**Addendum 1:**

CDBG-DR WATERSHED RESILIENCE & NRCS EMERGENCY WATERSHED  
PROTECTION IMPLEMENTATION PROJECT:

COAL CREEK CANYON EWP PROJECTS

January 3, 2017

**SHEET 3 of 33**

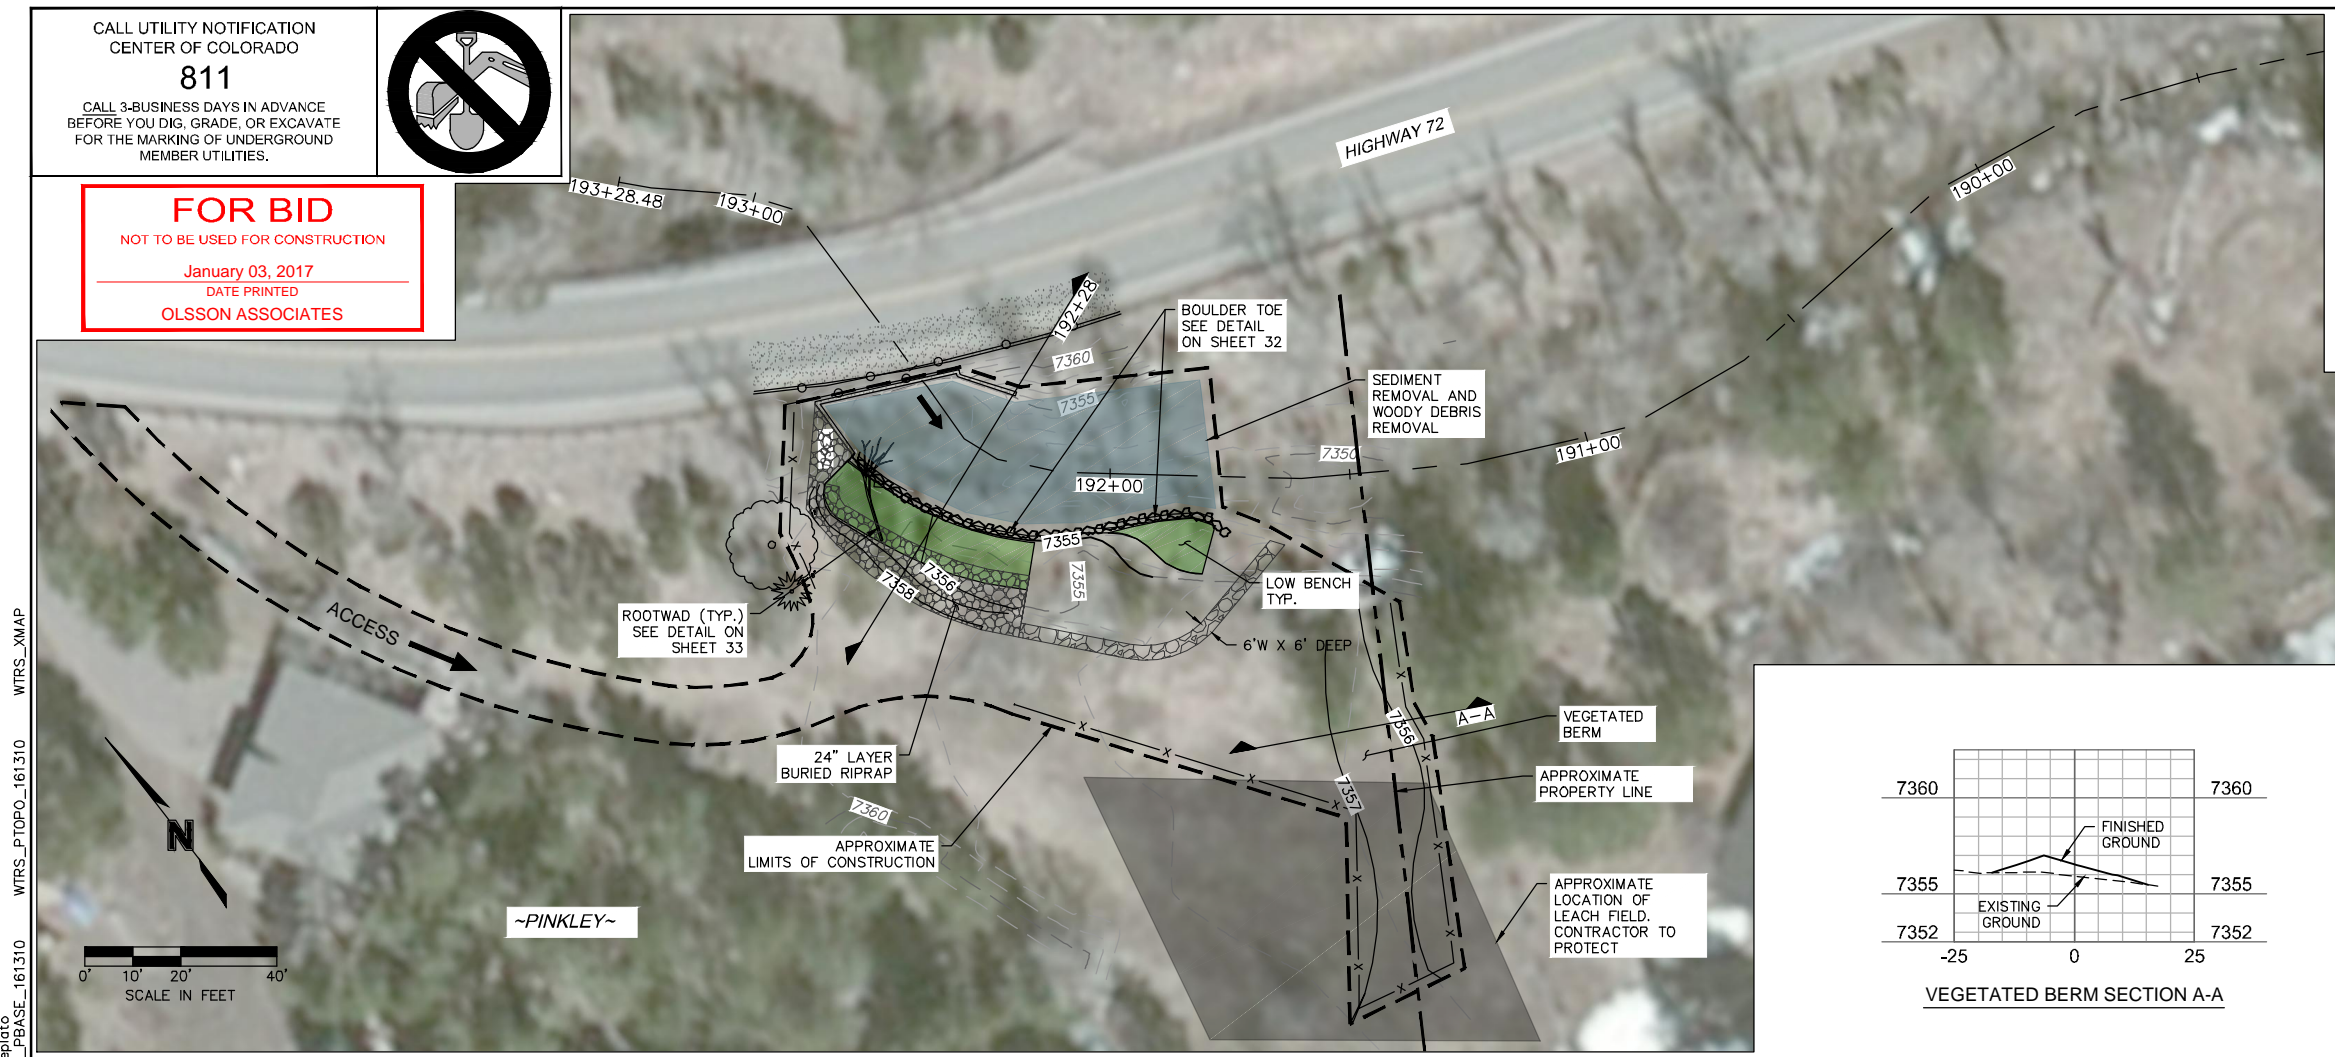
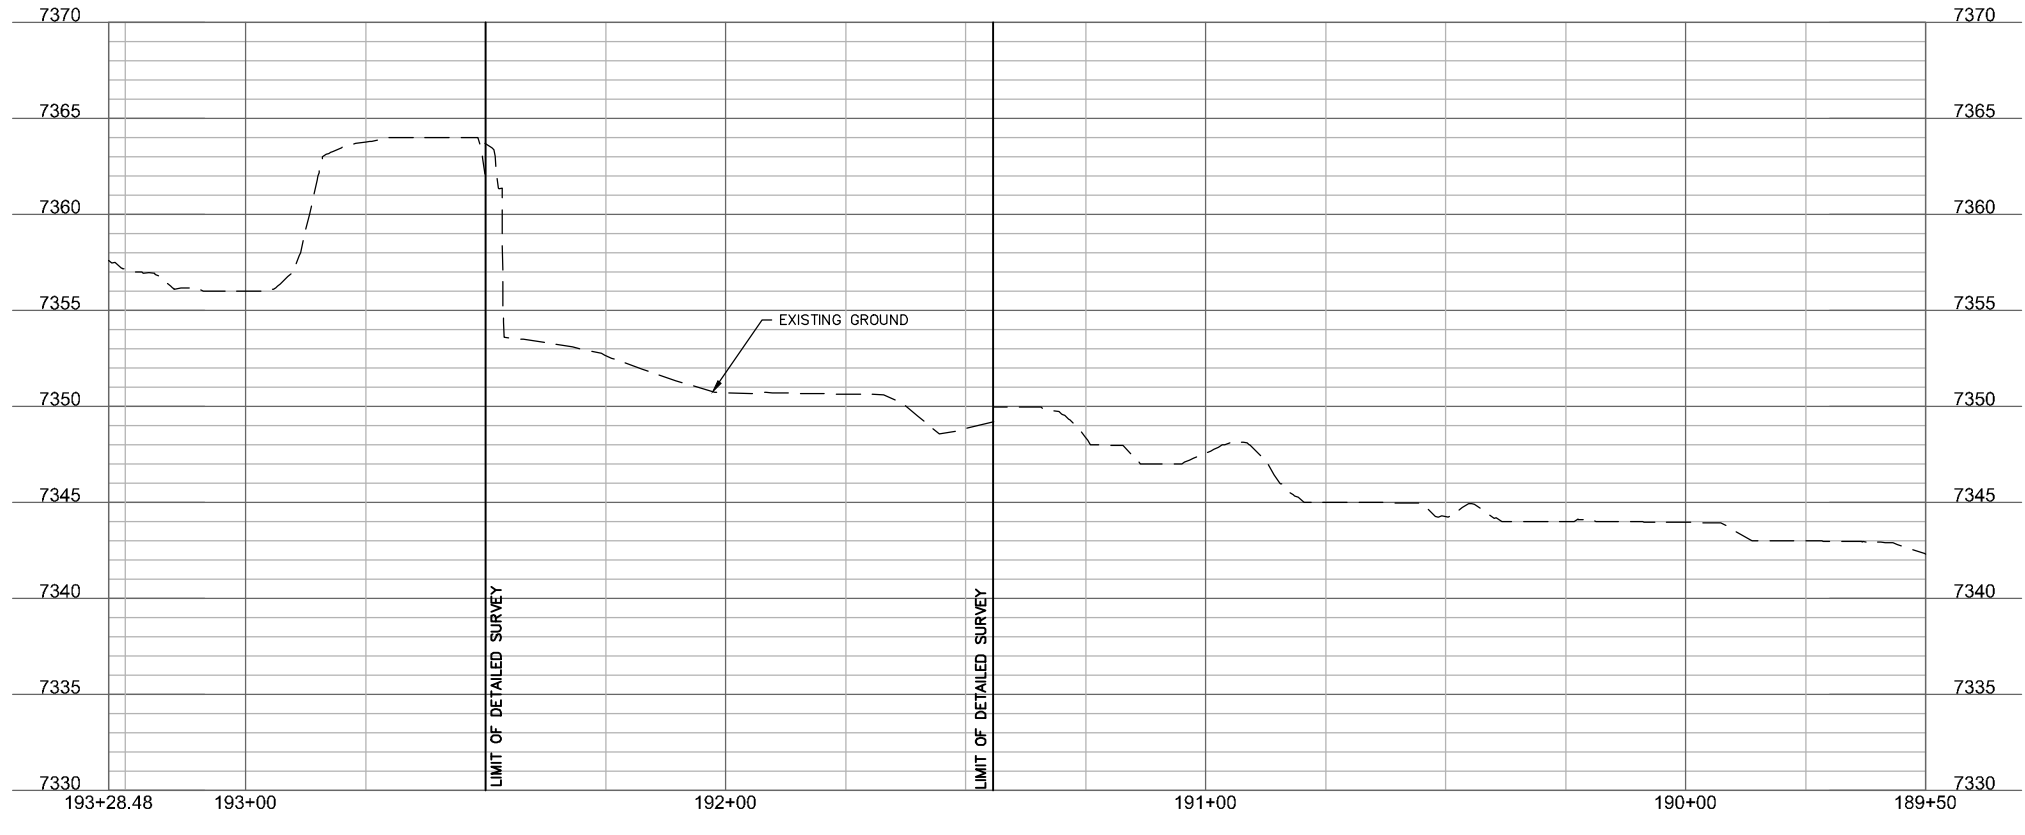
4. “Could you provide the cut/fill volumes on Sheets 3, 4, 6, 9, 10, 11 and 12? The values are not legible on the provided drawings.”

**Revised sheets are included in Addendum 1.**

**SHEET 4 of 33**

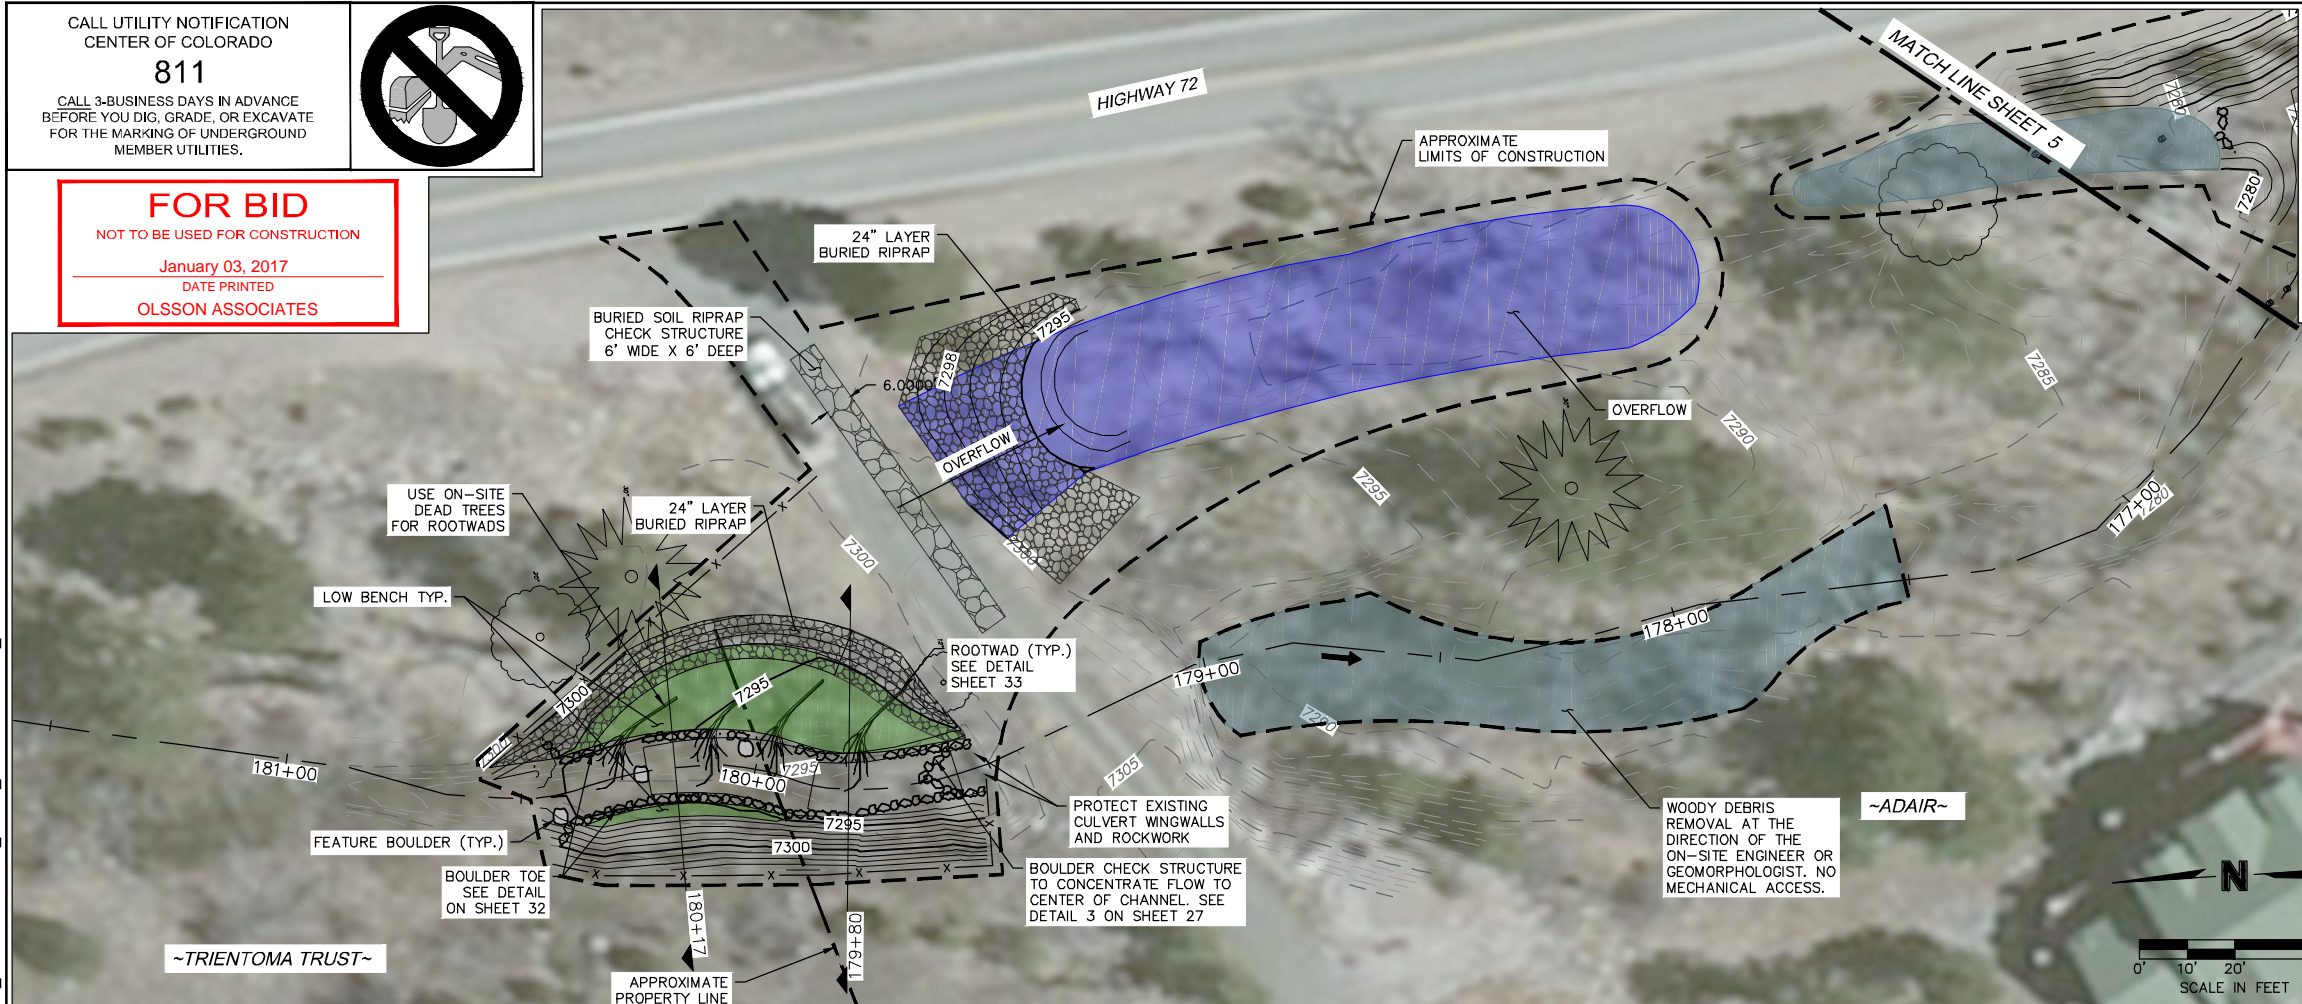
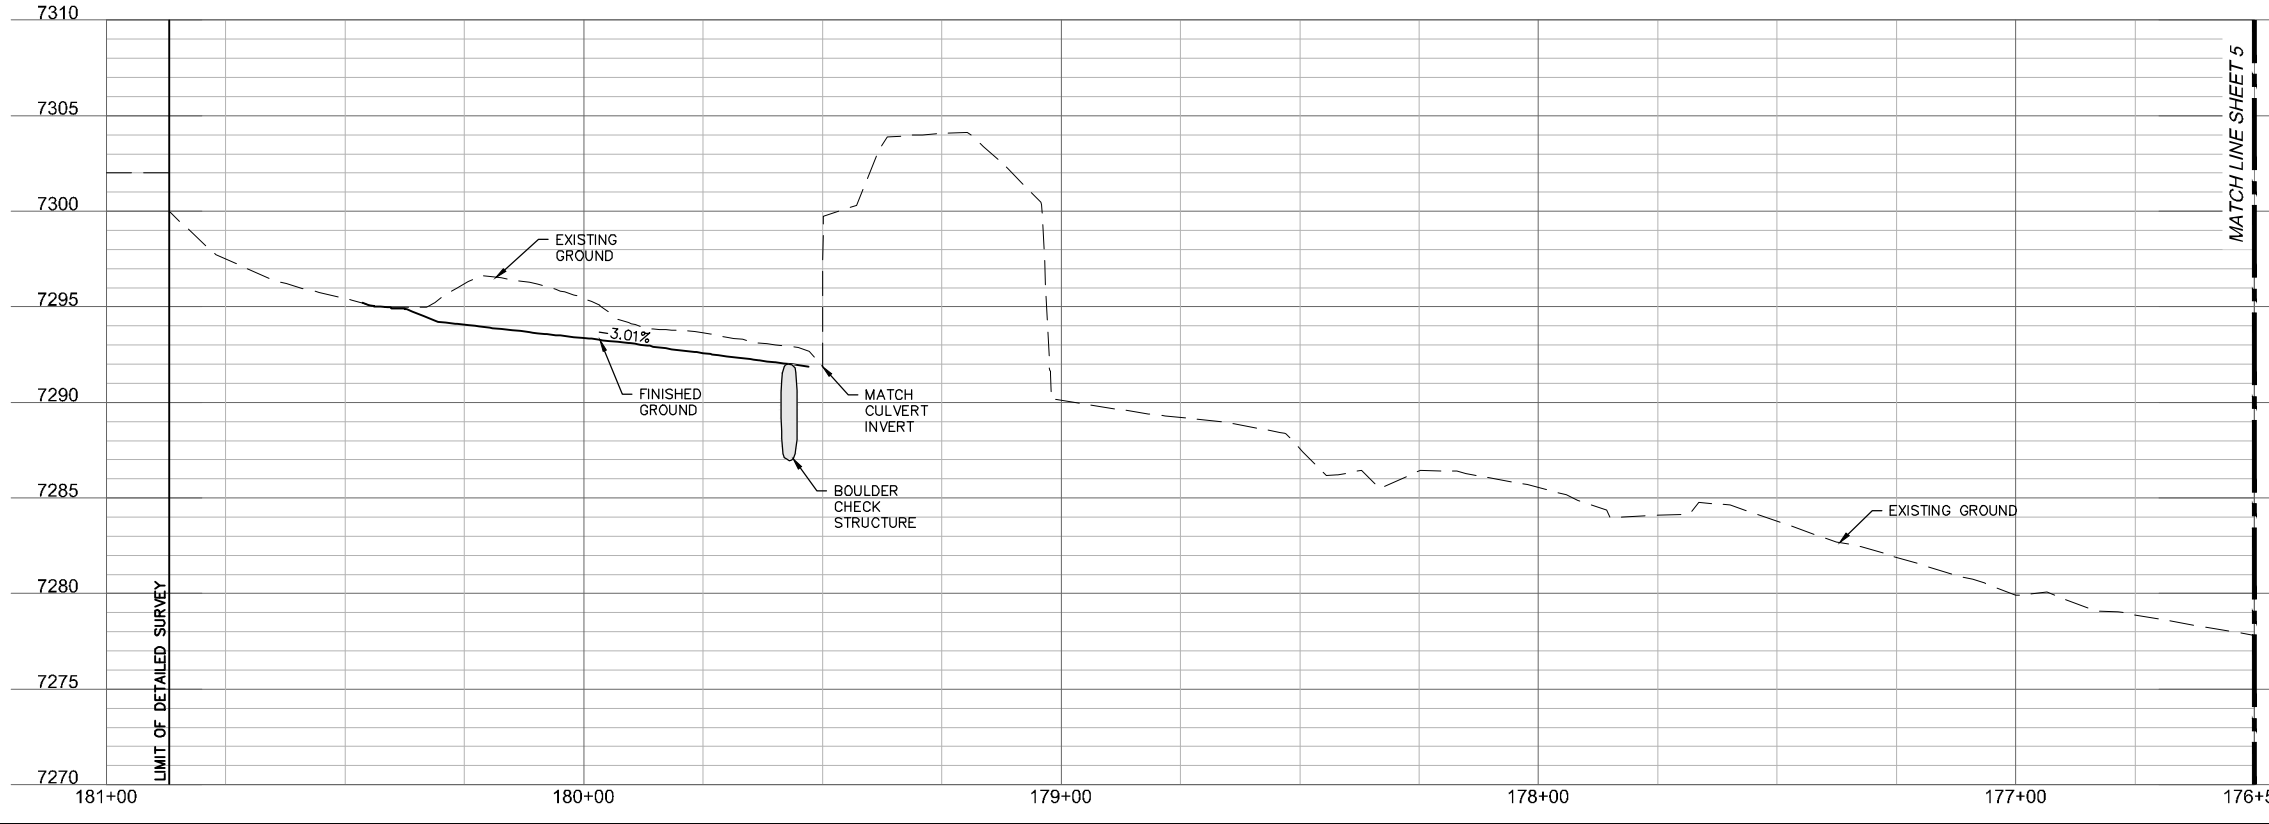
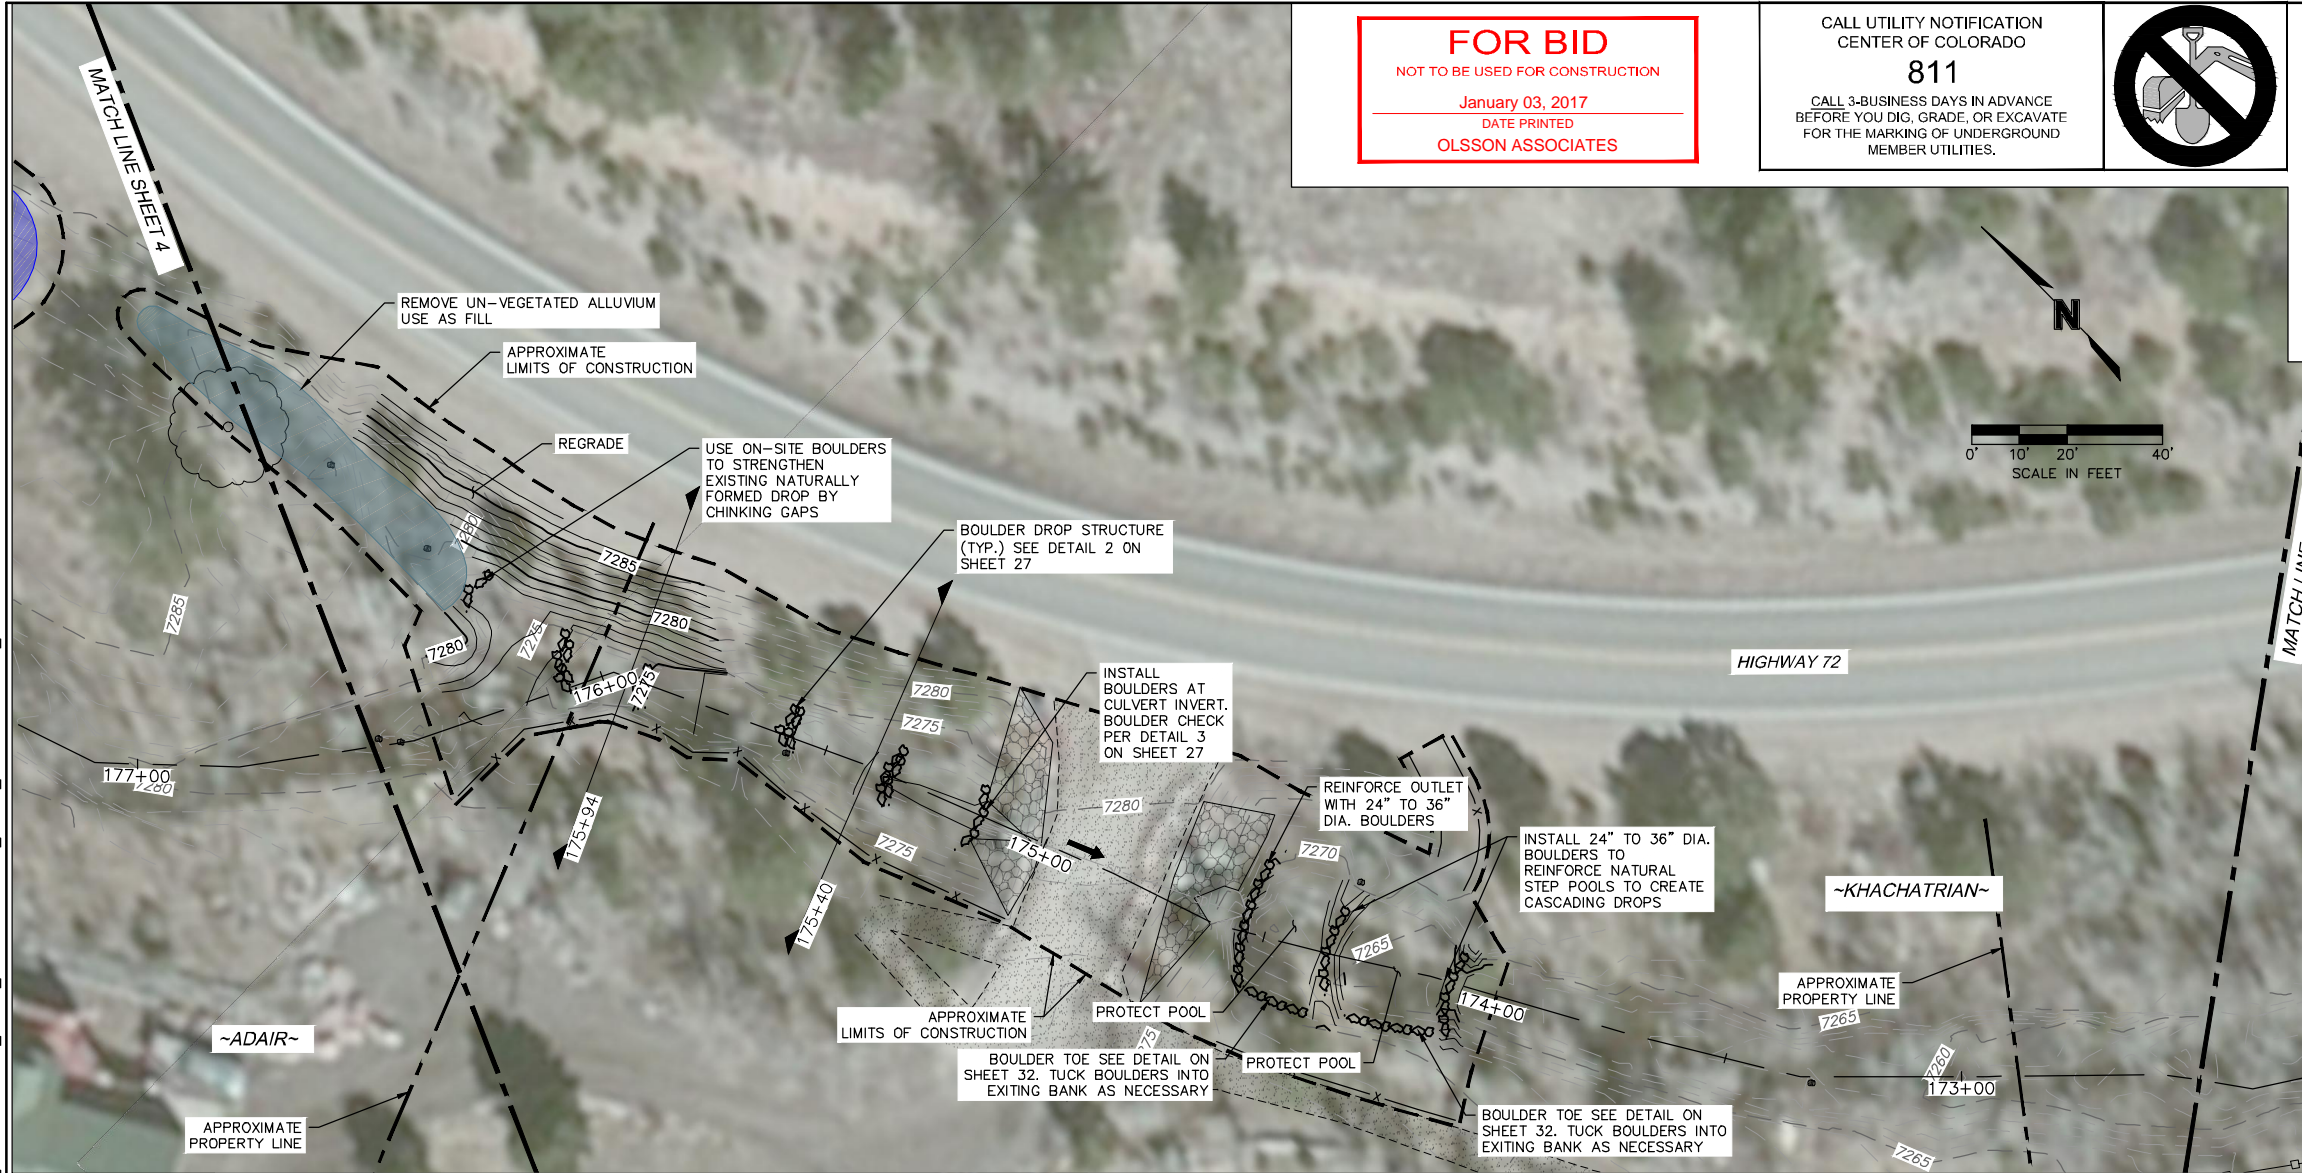
10. "Where are the 24 trees to be removed specified on the bid sheet?"

**With the exception of the trees shown on Sheet 4, upstream of the culvert, all tree removals will be determined in the field by the on-site Geomorphologist or Engineer. The quantity of trees removed is an estimate on the bid form and may or may not match the quantity removed in the field.**
